NOTICE OF MEETING

City of Ryde Local Planning Panel Meeting No. 7/19

DA Number	LDA2018/0385
Site Address & Ward	8 Grove Lane, Eastwood West Ward
Zoning	R2 Low Density Residential
Proposal	New multi-dwelling housing development comprising 3 x two storey 3 bedroom dwellings, 1.0m high front fence, associated car parking and tree removal.
Property Owner	Xiao Chun Yan
Applicant	Steve Wu
Report Author	Hussein Bazzi – Assessment Officer
Lodgement Date	4 October 2018
No. of Submissions	Twenty – seven (27) submissions objecting to the development. Seven (7) submissions to the amended plans.
Cost of Works	\$955,350.00
Reason for Referral to LPP	Contentious Development – Development is the subject of 10 or more unique submissions by way of objection

Figure 18: Section A showing the locations of excavation and fill.

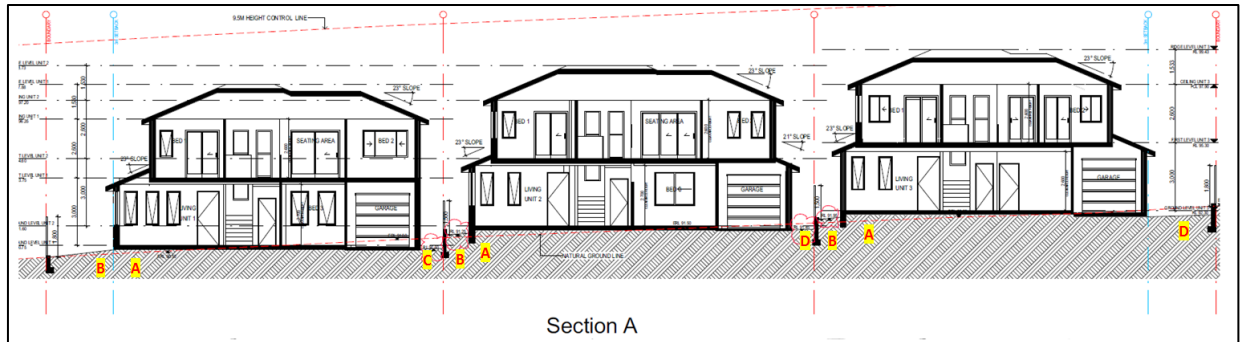
- Excavation of up to 500mm (at maximum) to the northern portion of the site within front setback adjacent to Unit 1.

- A: Fill 200mm – 300mm contained underneath the living areas of each Unit;
- B: Fill external to the buildings footprint to the western side of each dwelling of 200mm – 440mm;
- C: Excavation up to 500mm at the eastern side of the Unit 1; and,
- D: Excavation up to 400mm to the eastern side of Unit's 2 and 3.

The proposal has been designed utilising hipped roof form presenting to Grove Lane and does not comply. The proposed roof has a pitch of 23°, as shown in **Figure 18** above.

Figure 20: Ground floor setback to the eastern boundary for Unit 2.

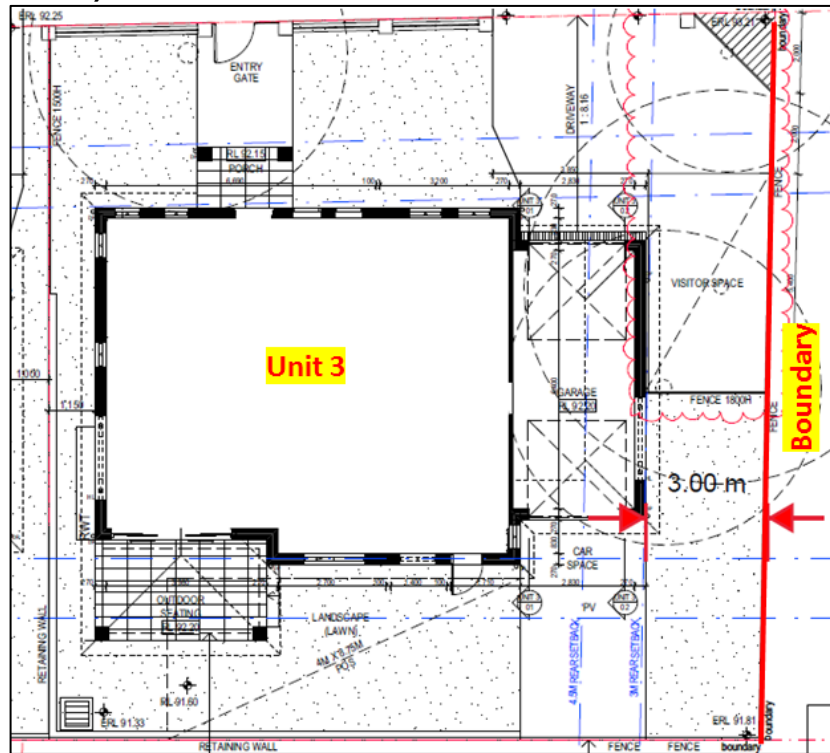
The eastern elevation of the garage for Unit 3 is setback 3.0 metres from the boundary. The entire length of eastern elevation of the garage is setback 3.0 metres and does not comply with the maximum allowable reduction of setback to 3.0 metres for 50% of the wall length. **Figures 20 and 21** below show the setbacks on the ground and first floor. The first floor is setback 4.5 metres and complies.

Figure 25: Location of landscape strips along the boundaries (as shaded).

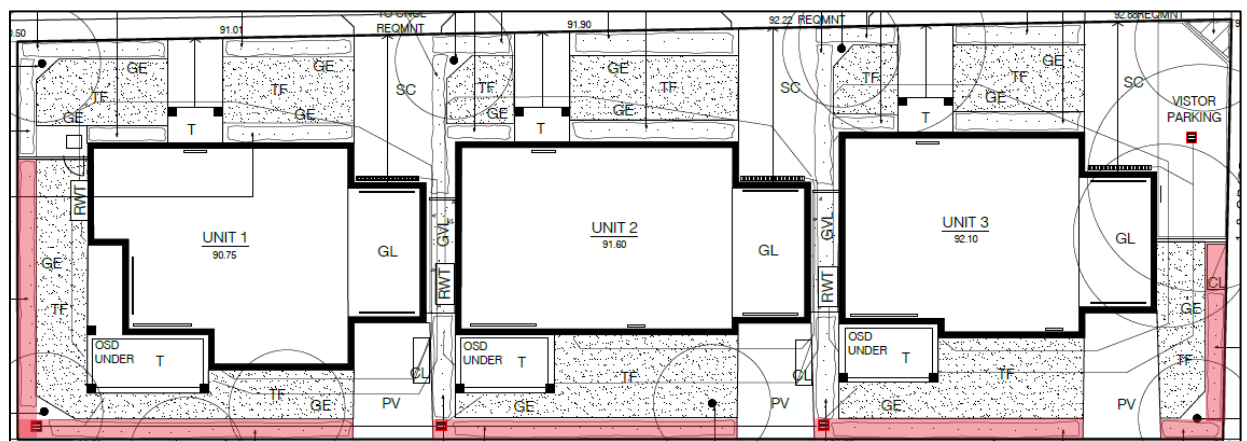
The proposal provides for a landscape strip of 800mm between the private open space of each unit and the adjoining dwellings and does not comply with the control requirement. The objective behind the control is to ensure that privacy is maintained between occupants of dwellings within the development and adjoining properties.

Although a 800mm wide landscape strip has been provided, to ensure that privacy is maintained between the of the occupants of dwellings within the development and adjoining properties, **Condition 29** is recommended, for the proposed retaining walls be set in a minimum 1.2 metres from the western side and southern rear boundaries and the natural ground level being maintained.

Figure 26: Extent of shadow cast the POS of Units 2 and 3 during mid-winter.

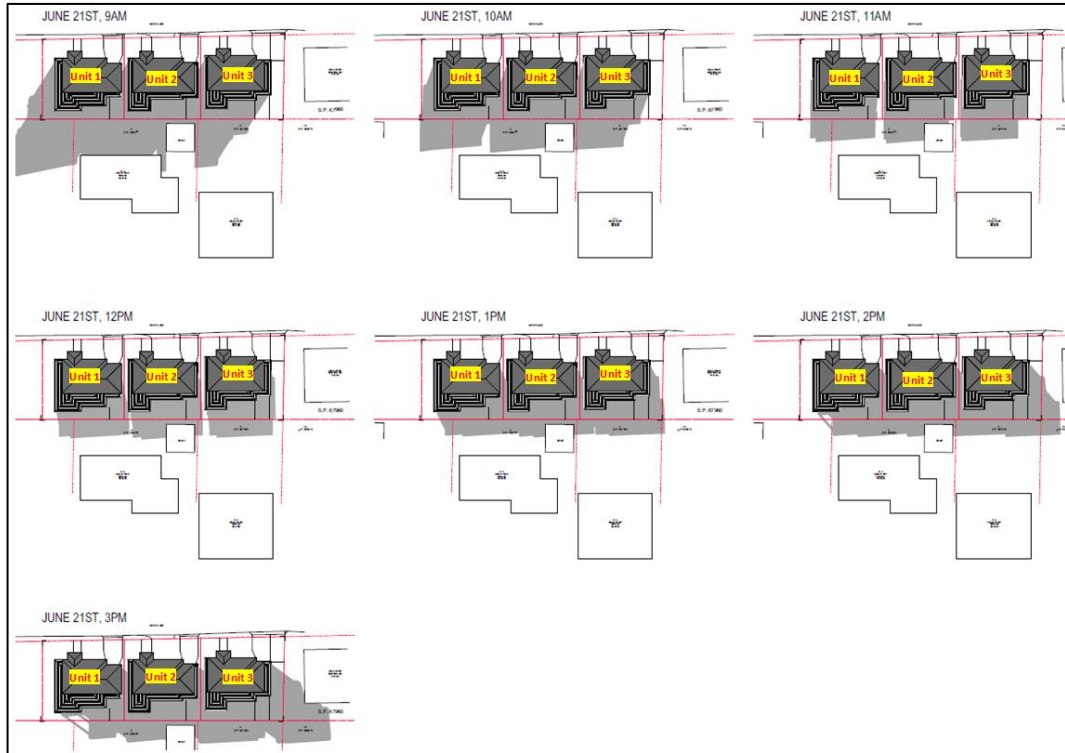
Control 3.9(b) requires multi dwelling housing developments to provide two (2) hours sunlight to at least 50% of each courtyard within the development. The private open space for Unit 1 is compliant with the control. The primary open space being the alfresco area has a western aspect and will achieve at least two (2) hours sunlight to 50% of its surface from 12 noon. The private open spaces of Units 2 and 3 will not achieve the required solar access as shown in **Figure 26** below.

Figure 27: Northern elevation showing the location of balconies on the first floor.

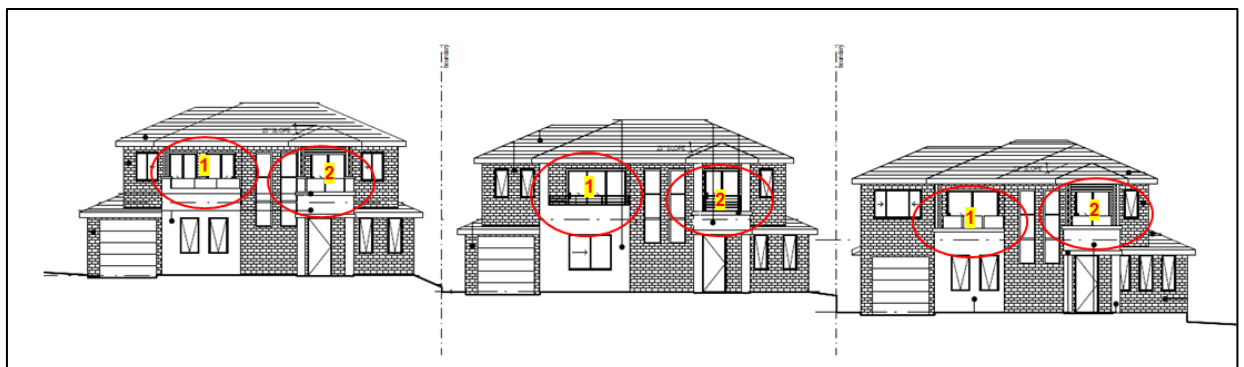
The proposal includes balconies to the northern elevation presenting to Grove Lane. **Figure 27** shows the locations of the balconies within the northern elevation.

The proposed balconies labelled 1 are associated with sitting areas and the balconies labelled 2 are associated with bedrooms.

Figure 35: Figure showing the cross slope across the nominated crucial portions of the site.

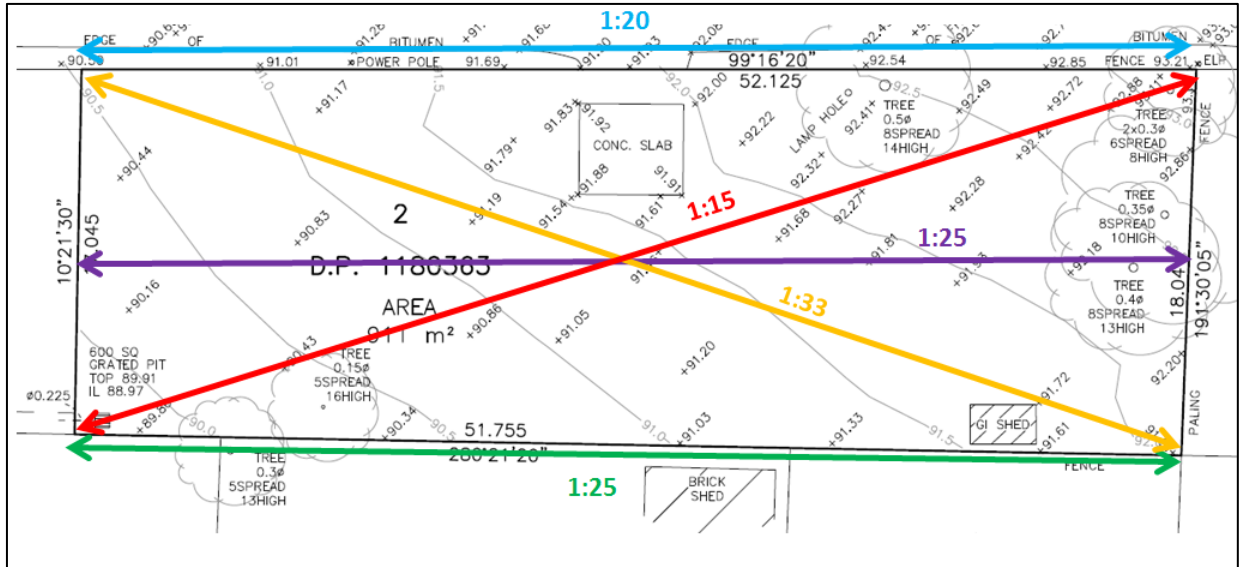
The proposal is considered to be appropriately designed in response to the site's topography. As shown in **Figure 35** below, the overall cross fall across various portions of the site will not exceed 1:14 and is consistent with the objectives of the control for the following reasons:

Figure 16: Site plan demonstrating where the 20 metre width is achieved.

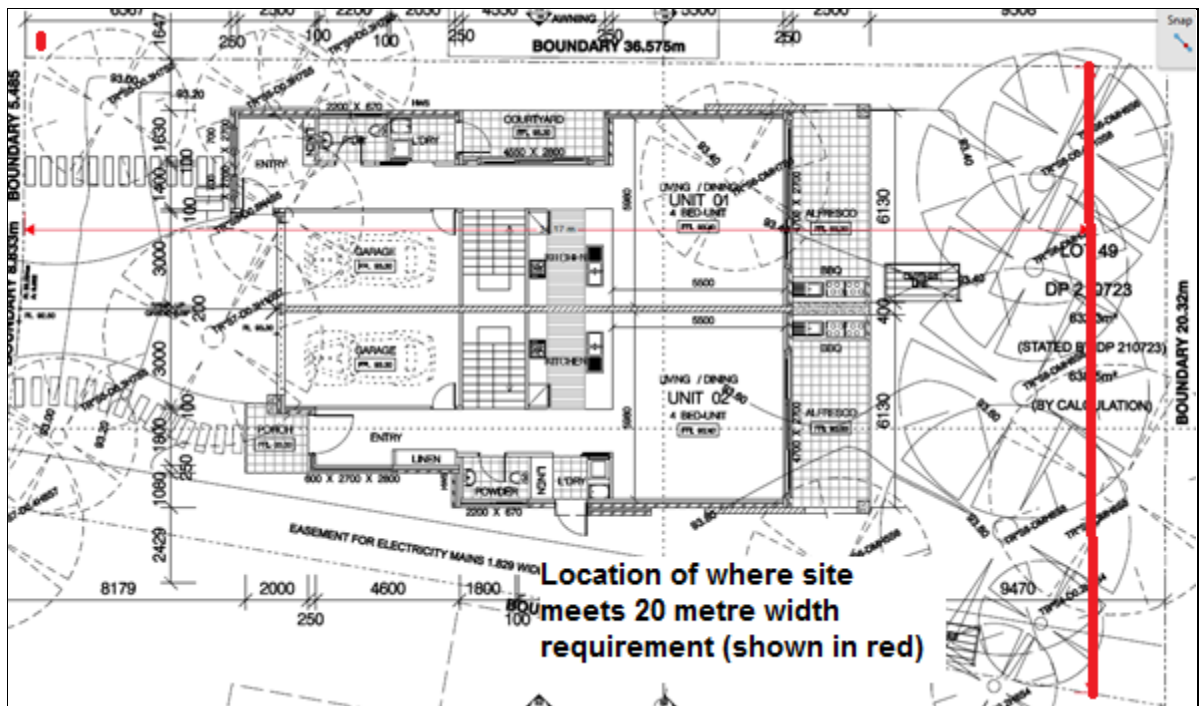
- The Applicant states that the width of the dwellings at the building line is 15.29 metres. The site does not meet the minimum 20 metre width requirement until 34.17 metres into the site and results in only 49m² of site area meeting the 20 metre requirement. The site would then be non-compliant with the minimum site area requirement of 580m² required by Clause 4.1B(2)(a). (**Figure 16**).

Figure 16 represents the location on the site in which the minimum 20 metre width required by Clause 4.1B(2)(b) is achieved. At this point, The site area is 49m² which is a significant departure from the 580m² site area required by Clause 4.1B(2)(a).

Figure 18: Measurements of the garage location from the dwellings main façade.

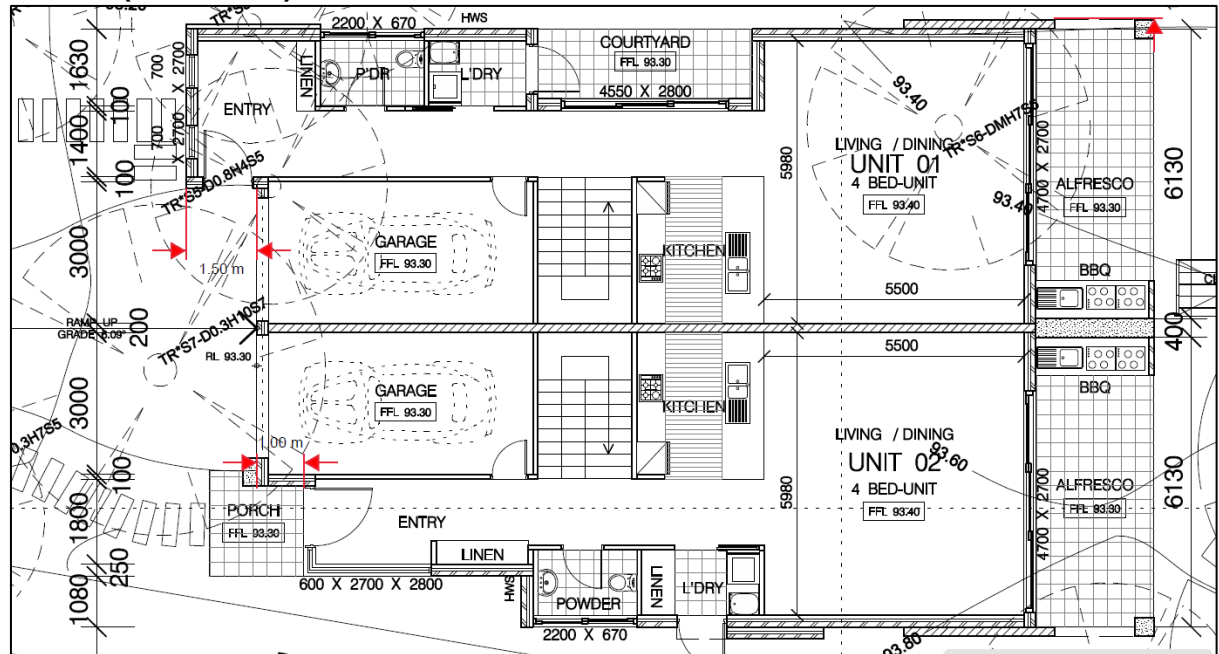
The proposed garage is setback 1.5 metres behind the façade of Unit 01, however the proposal is non – compliant with Controls 2.9.1(c), 2.11.1 (c) and (p)) as the garage protrudes 1.0 metres in front of the main façade of Unit 02 (**Figure 18**).

Figure 19: Proposed side setbacks from northern boundary at rear.

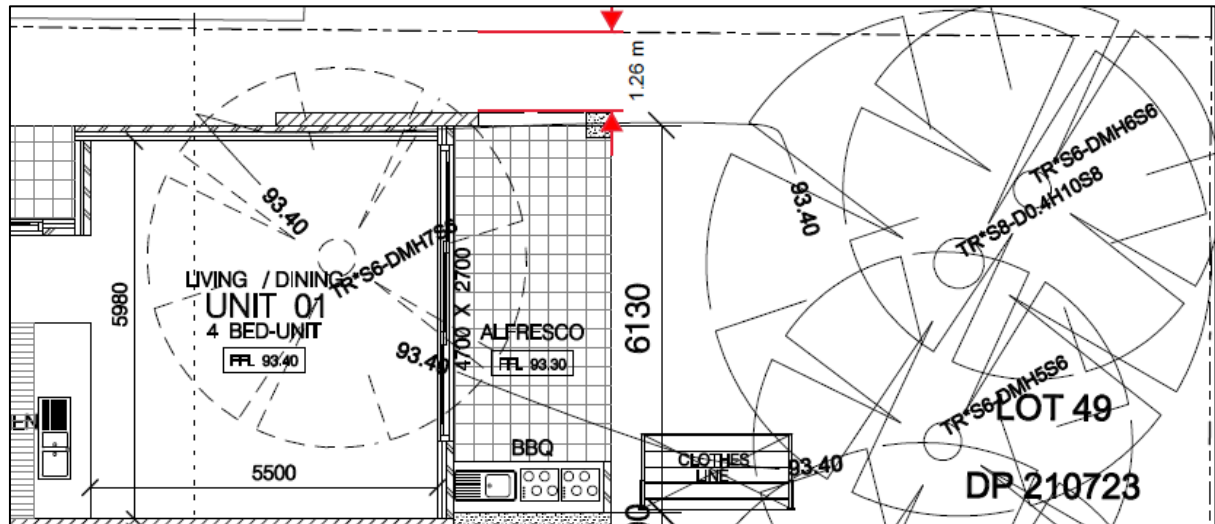
The proposal is calculated to be non-compliant with the required side setback at the rear of proposed Unit 01. Council's measurements indicate that the side setback to the northern boundary is 1.26 metres at the ground floor and first floor (**Figure 19**). The proposal is non-compliant with the control.

Figure 20: Northern elevation showing proposed openings

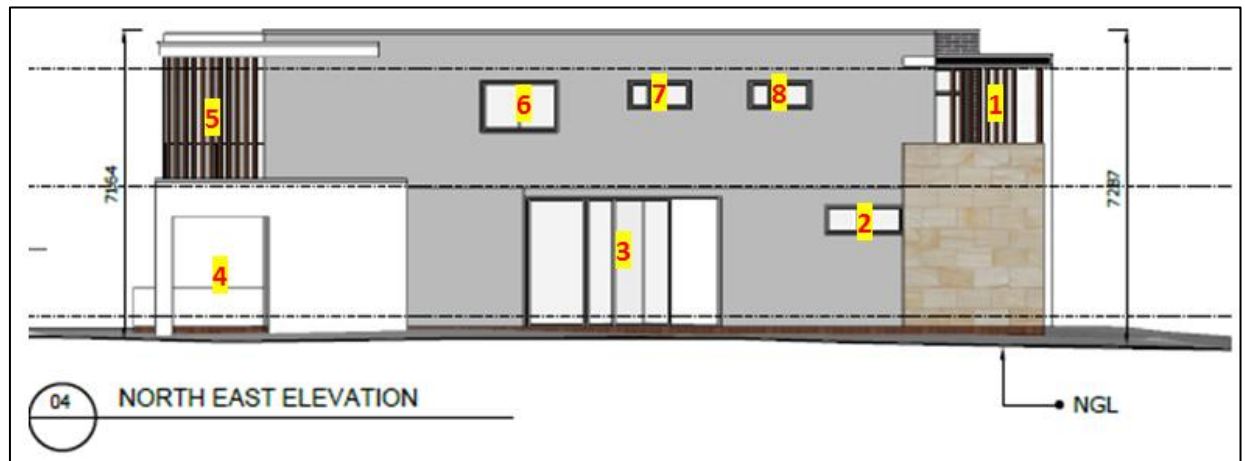
The proposal contains eight (8) openings within the northern elevation presenting to 55 Lavarack Street. **Figure 20** below shows the location of those openings.

- Item 1 is a first floor balcony accessible via the master bedroom of Unit 01. The balcony has a depth of 3.63 metres and includes fixed louvers along the northern elevation for a length of 2.2 metres of the balcony. The adjoining dwelling is setback from Lavarack Street and the proposed screening depth would prevent overlooking of the adjoining dwelling;
- Item 2 is a ground floor window which services a bathroom and consists of a sill height 1.8 metres above the finished floor level (FFL), resulting in no impact on overlooking into 55 Lavarack Street;
- Item 3 is the ground floor courtyard access which are sliding doors that are orientated to the northern boundary. The finished level of the courtyard is RL93.30 and the general level of sightlines is at RL94.90. Sightlines will be concealed by a 1.8 metre high boundary fence, with the top of the fence at RL95.07;

Figure 9 Location where 20 metre width achieved and resultant site area meeting the width

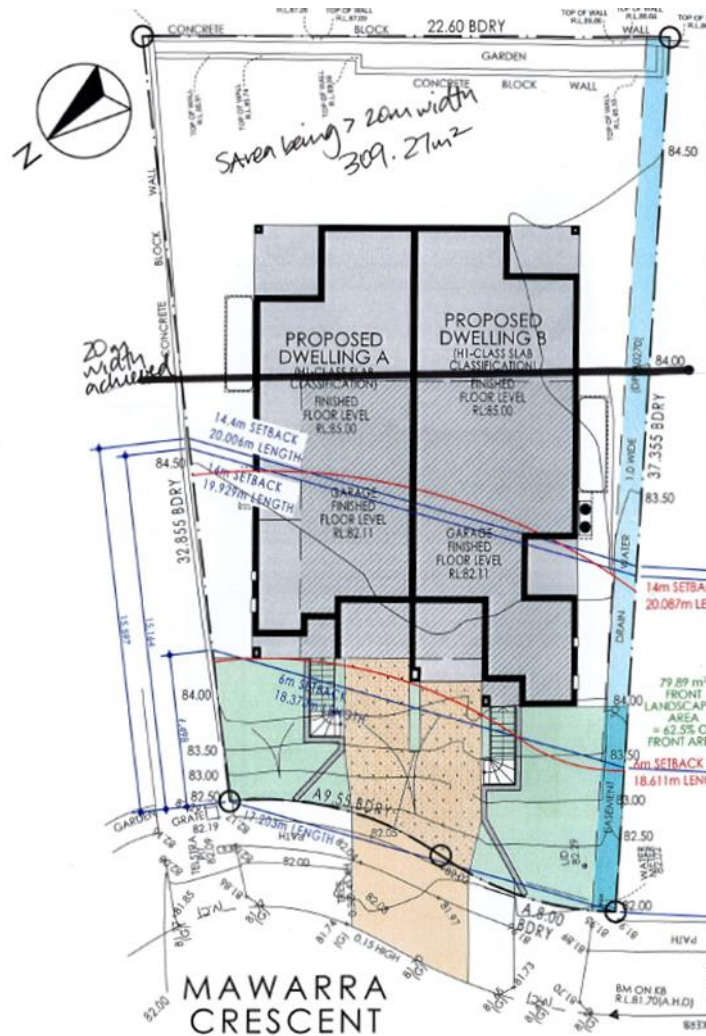
Consideration is given to how the site performs in regards to both numerical requirements. **Figure 9** shows that the site area of 309.27m² meets the 20 metres frontage requirement. The site does not meet the 20 metres required width until 18.2 metres along the northern side boundary and 23 metres along the southern boundary. Whilst the standard does not require an entire site to meet the 20 metre frontage, it provides context to the site's performance against the standard as a whole. The site at no point satisfies both the requirements of (a) and (b).

Figure 11 Section A-A Sheet 14 of 17 Issue B5 prepared by SETT Homes

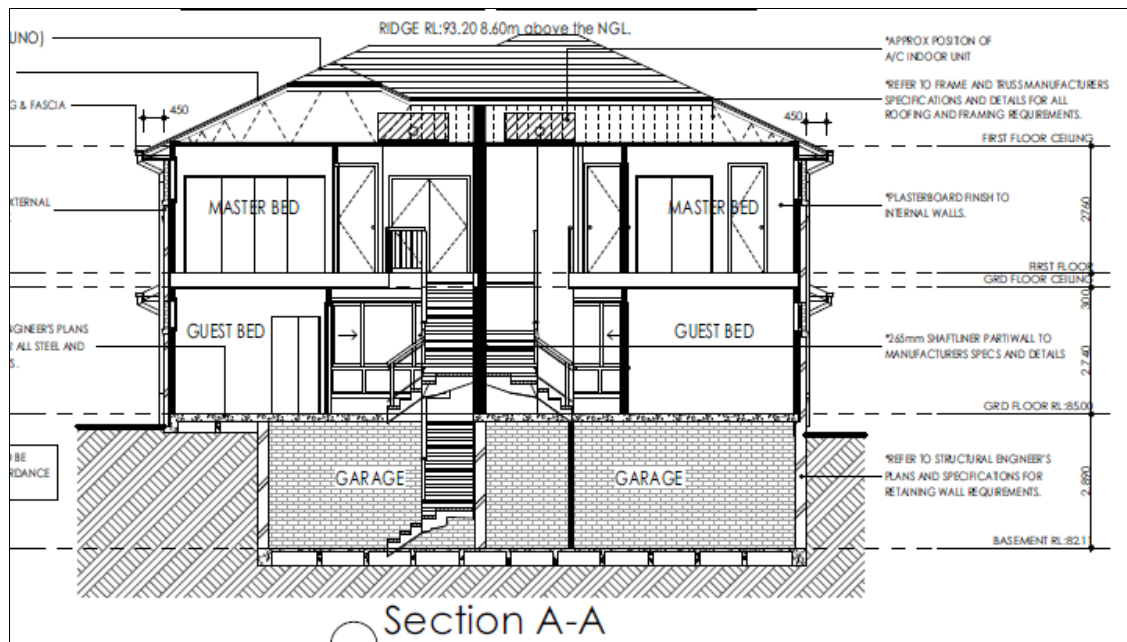
Section A-A (**Figure 11**) shows a 500mm difference between the ground floor and adjoining natural ground level along the south western side boundary. The section is taken through the guest bedrooms, where the existing ground level is approximately RL84.5 along the south western side boundary and RL84.45 (when referenced against Sheet 3 and Sheet 9). The finished ground level or RL85.00 would mean there is a level difference of 500mm which has not been responded to within the design.

Figure 12 South western elevation Sheet 13 of 17 prepared by SETT Homes

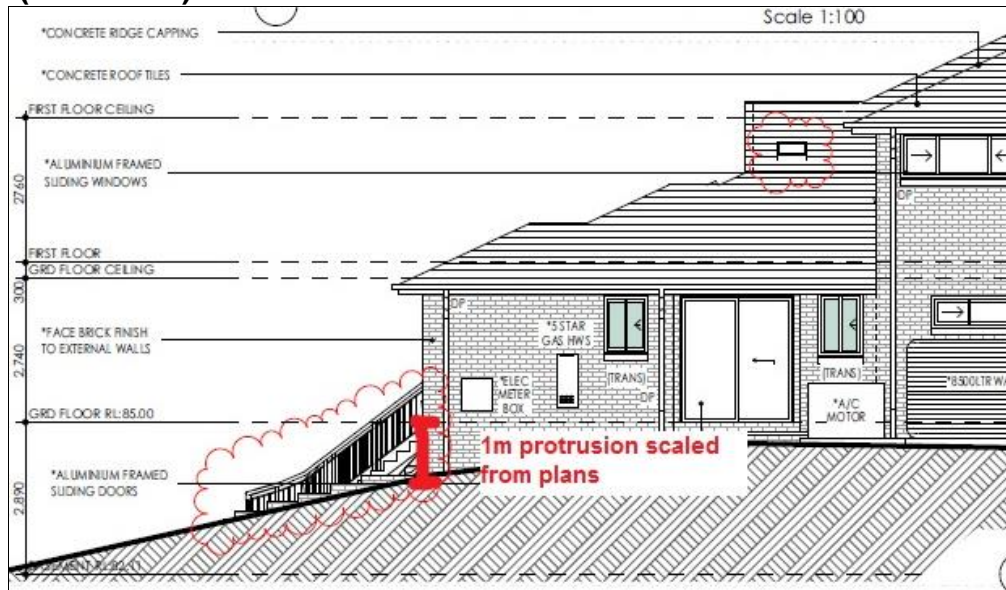
Semi-basement car parking is a car parking structure set partly below ground level. The proposed basement would result in a maximum height of 700mm above natural ground at the south-western corner. This is inconsistent with what is shown on the submitted plans (**Figure 12**) south western elevation shows 1.0 metre protrusion. The absence of a long section through the development contributes to a misrepresentation of the levels across the site and the extent of level changes proposed. A cross section has also not been provided across the front of the site where the basement protrudes the greatest height above natural ground.
